April 5, 2018

RE: Westmount Public School - Renovations  
Peterborough, Ontario

Job #: 17244

## MECHANICAL AND ELECTRICAL ADDENDUM

PARTIAL KEY PLAN  
SCALE: N.T.S.

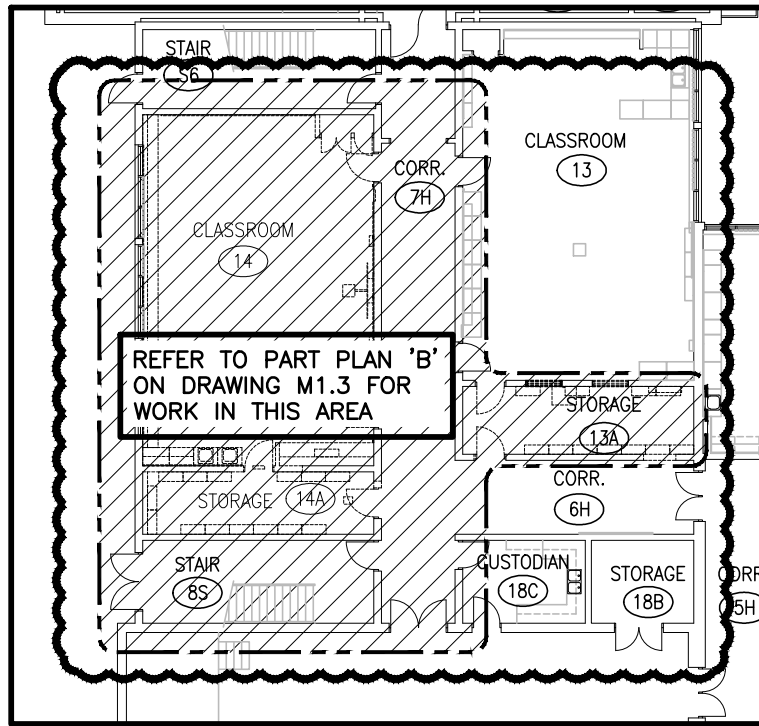
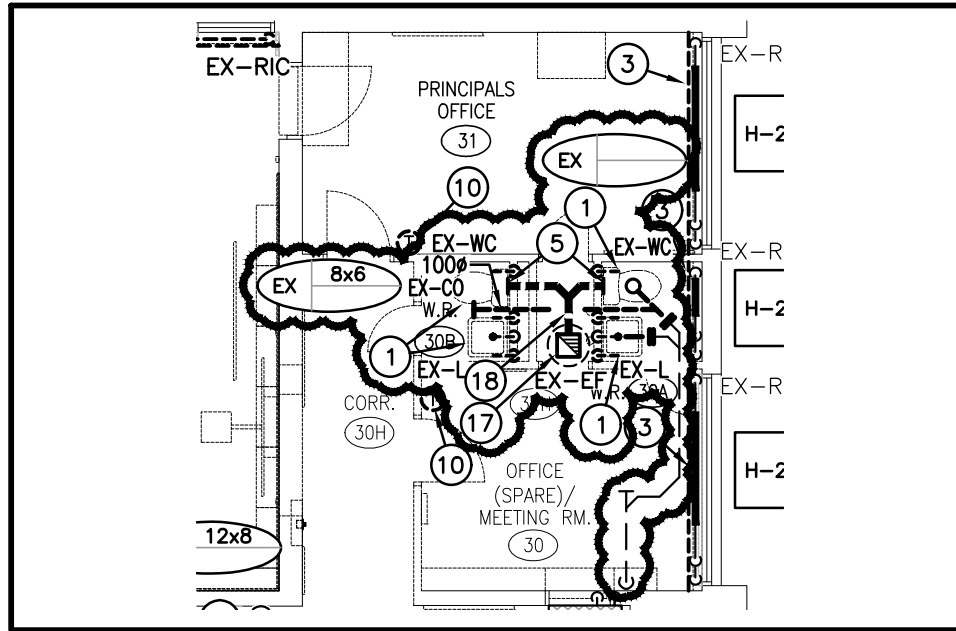
- 2.0 Reference Drawing M1.1 and Attached Sketch SKM-1.
- .1 In the Plumbing Fixture Schedule, add watercloset WC-2 and lavatory L-2 as per Sketch SKM-1.
  - .2 Revise Part Plan ‘B’ area on First Floor Key Plan as per Sketch SKM-1.
  - .3 In the Unit Ventilator Schedule, revise UV-101 model to VUV-1200.

Item	Type	Sanitary (mm)	Vent (mm)	CW (mm)	HW/TW (mm)
WC-1	FLOOR MOUNTED FLUSH TANK WATERCLOSET (ROUND FRONT) (KINDERGARTEN)	80	40	15	N/A
WC-2	FLOOR MOUNTED FLUSH VALVE WATERCLOSET	80	40	25	N/A
*L-1	WALL MOUNTED LAVATORY (KINDERGARTEN)	32	32	15	15
L-2	WALL MOUNTED LAVATORY	32	32	15	15
S-1	SINGLE COMPARTMENT STAINLESS STEEL SINK	40	32	15	N/A
*S-2	SINGLE COMPARTMENT STAINLESS STEEL SINK	40	32	15	N/A
FD-1	GENERAL DUTY FLOOR DRAIN	SEE PLAN	40	N/A	N/A

**PARTIAL FLOOR PLAN – DEMOLITION**

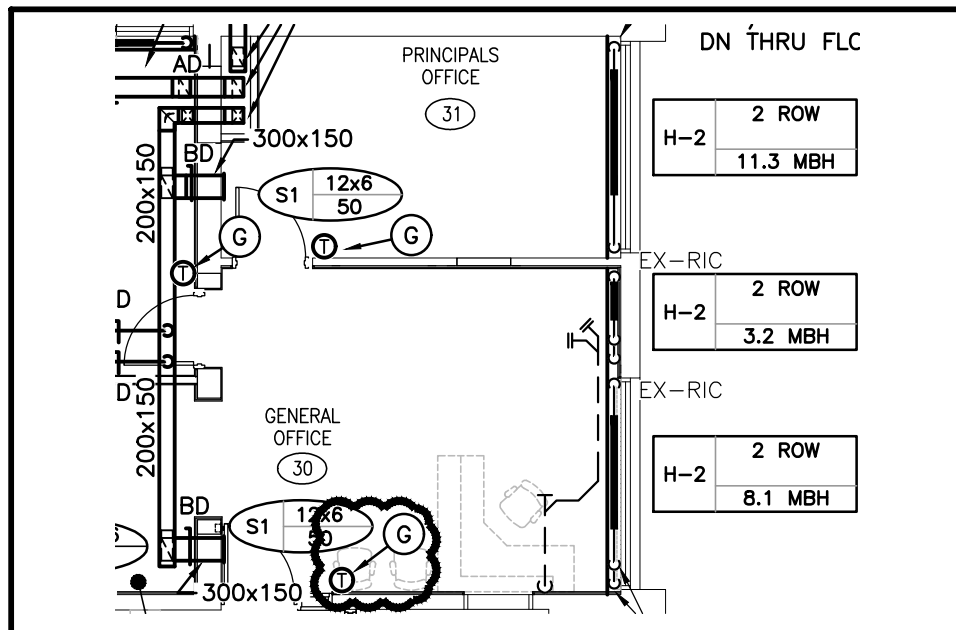
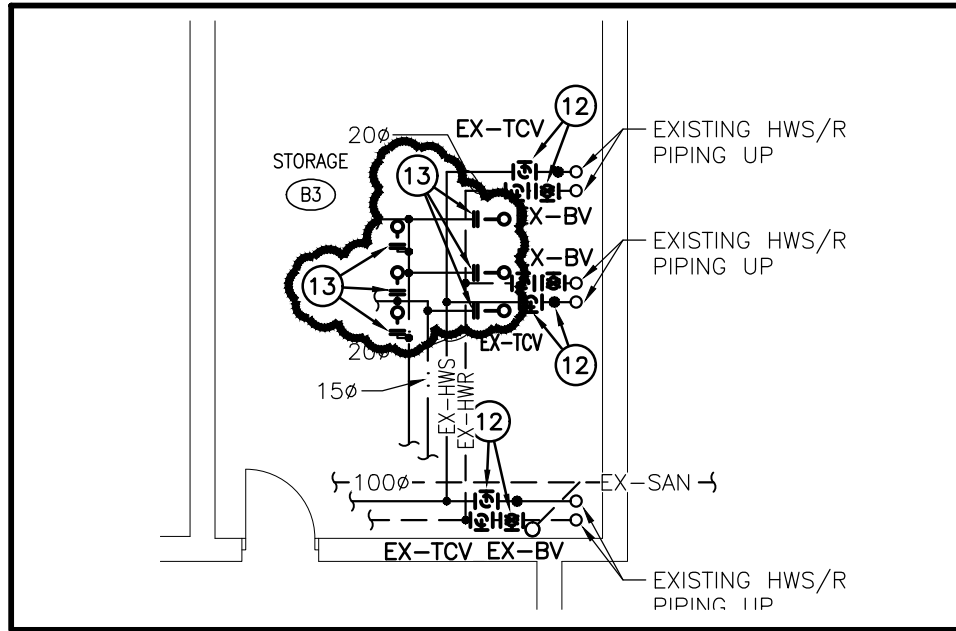
- 3.0 Reference Drawing M1.2 and Attached Sketch SKM-2.
- .1 Existing waterclosets and lavatories in Existing WR 30A and WR 30B to be removed. Existing domestic water piping and sanitary piping to be cut and/or capped as per Sketch SKM-2.
  - .2 Existing exhaust fan serving WR 30A and WR 30B removed complete as per Sketch SKM-2
  - .3 Existing exhaust wall grilles to be removed as per Sketch SKM-2.
  - .4 Revise Specific Demolition Notes as per Sketch SKM-2.
  - .5 Revise location of thermostat in General Office 30 as per Sketch SKM-2.
  - .6 On Part Plan ‘A’ Renovation Drawing, extend new H-2 radiation cabinet in Classroom ‘04’ North to partition wall complete with end cap (teaching wall).

- 17. EXISTING EXHAUST FAN ON ROOF TO BE REMOVED COMPLETE. CAP EXISTING ROOF CURB AS PER DETAIL. CONFIRM SIZE ON SITE.
- 18. EXISTING DUCTWORK TO BE REMOVED COMPLETE.

PARTIAL FLOOR PLAN – DEMOLITION  
 SCALE: 1/8" = 1'-0" 1:100

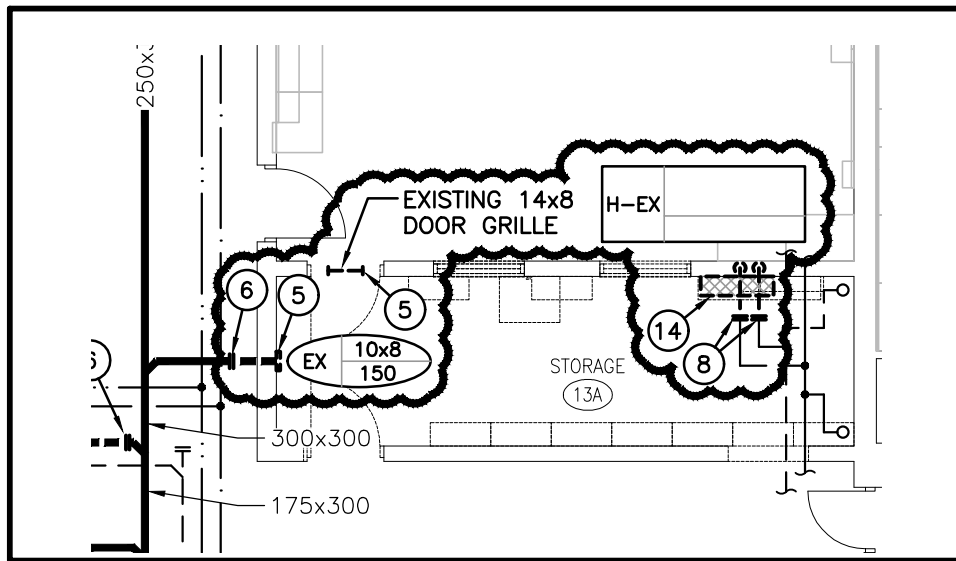
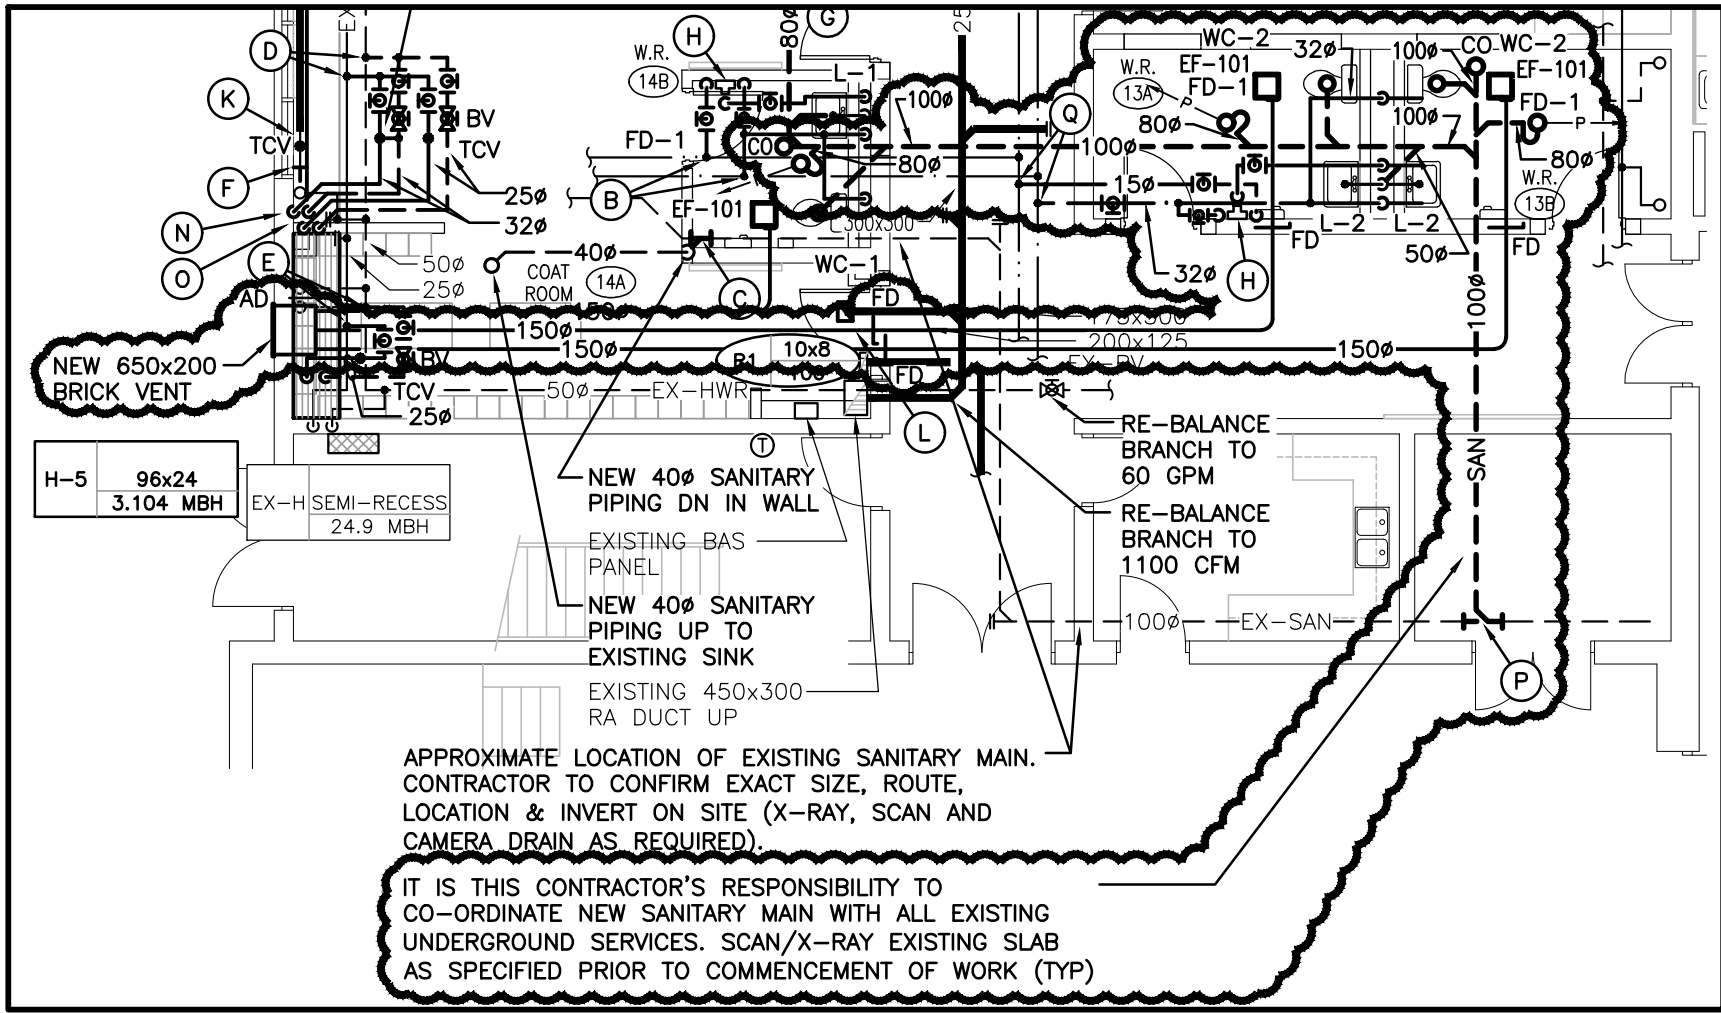
- 4.0 Reference Drawing M1.3 and Attached Sketches SKM-3 to SKM-6
- .1 Existing hot and cold water piping in Storage B3 to be cut and capped as per Sketch SKM-3.
  - .2 Specific Demolition Notes to be revised as per Sketch SKM-3.
  - .3 Remove existing ductwork in Storage 13A as per Sketch SKM-4.
  - .4 Remove existing cabinet heater in Storage 13A and revise piping as per Sketch SKM-4.
  - .5 Revise sanitary piping and domestic water for new WR 14B, WR 13A and WR 13B as per Sketch SKM-5.
  - .6 Provide two EF-101 in WR 13A and WR 13B and provide exhaust ductwork as per Sketch SKM-5.
  - .7 Revise Specific Renovation Notes as per Sketch SKM-5.
  - .8 Revise “Fire Hose Cabinet Detail” as per Sketch SKM-6.
  - .9 Add “Capped Roof Curb Detail” as per Sketch SKM-6.

- 13. EXISTING DOMESTIC WATER TO BE CUT AND CAPPED AND REMOVED BEYOND COMPLETE.
- 14. EXISTING CABINET HEATER TO BE REMOVED BEYOND COMPLETE.

**A-PART PLAN LIGHTING (DEMOLITION & RENOVATION)**

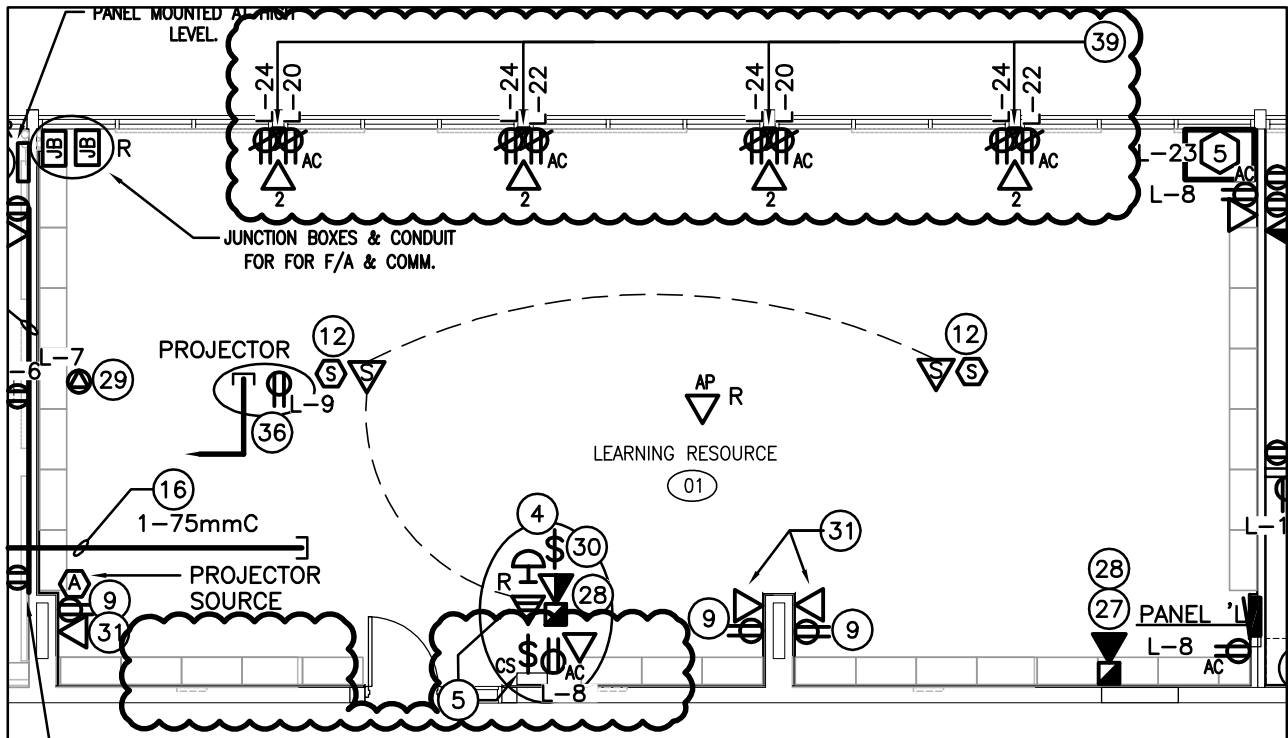
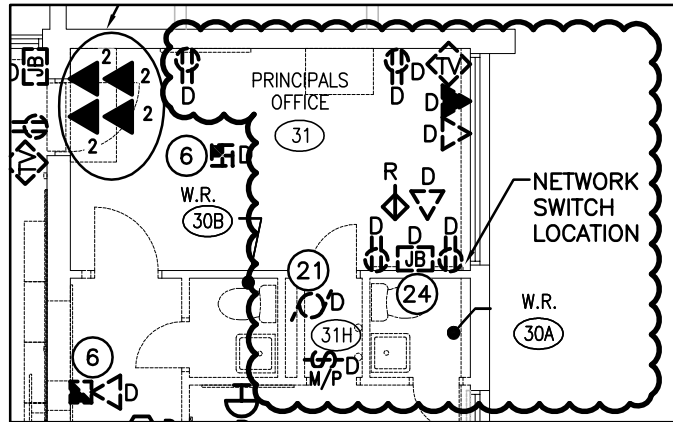
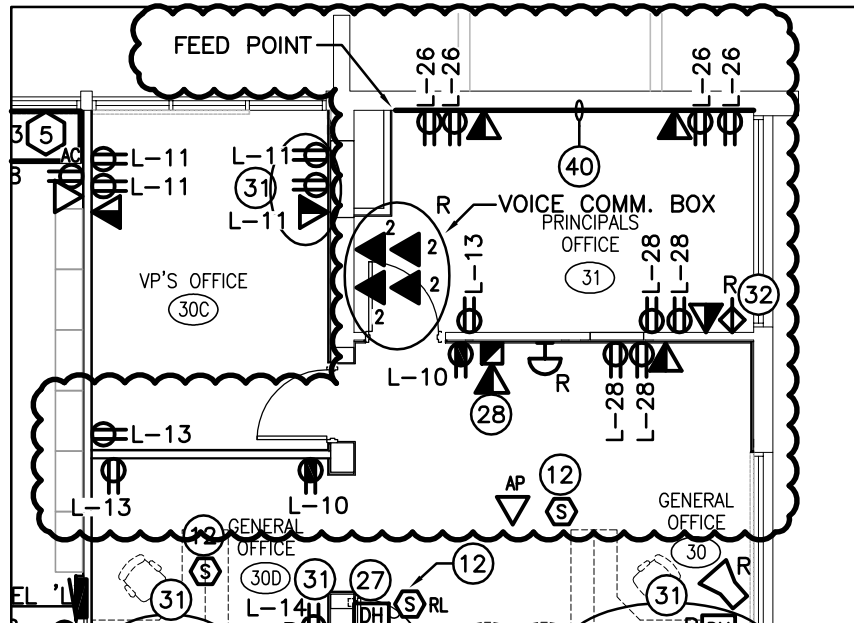
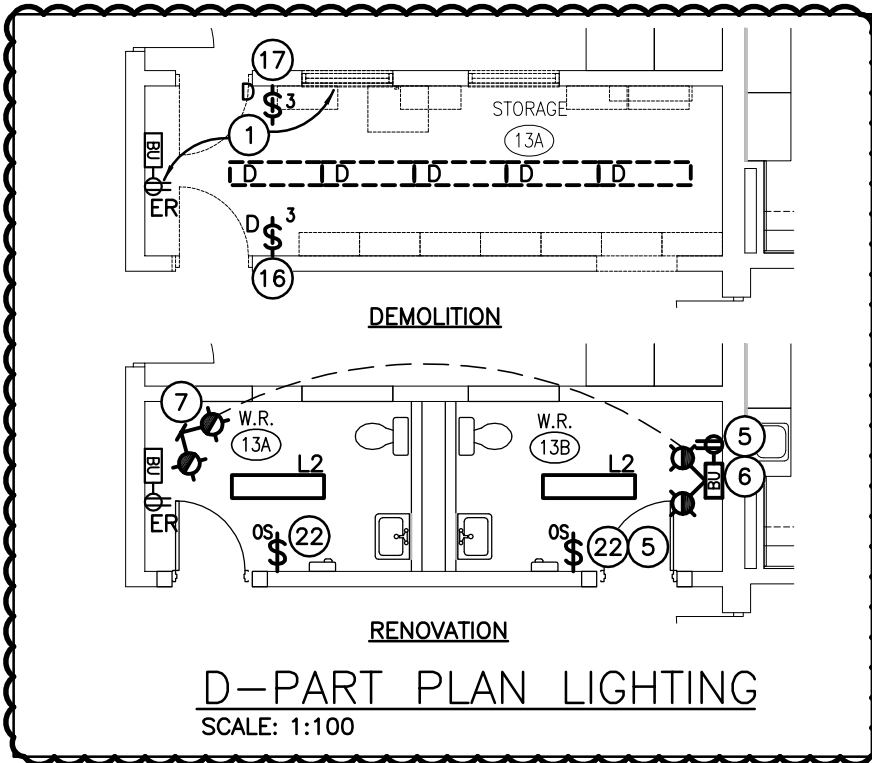
- 2.0 Reference Drawings E1.1, E2.0, E3.0 and Attached Sketches SKE-2 and SKE-3
- .1 On Drawing E1.1 on the schedule for panel 'L', provide:
    - Two (2) new feeds for receptacles in Principal's Office from existing spare 15A-1P breakers.
  - .2 On Drawings E2.0 and E3.0, revise devices in WR 30A, WR 30B, and Corridor 31H as indicated on SKE-2 and SKE-3 to suit removal of both washrooms.
  - .3 On Drawing E3.0 within Learning Resource 1, delete additional raceway as per electrical Addendum 1 Item 2.1. Provide new vertical raceway and devices as per SKE-2.
  - .4 On Drawing E3.0, revise devices in Principal's Office and General Office 30/30D as per SKE-2 and SKE-3 to suit removal of washrooms.
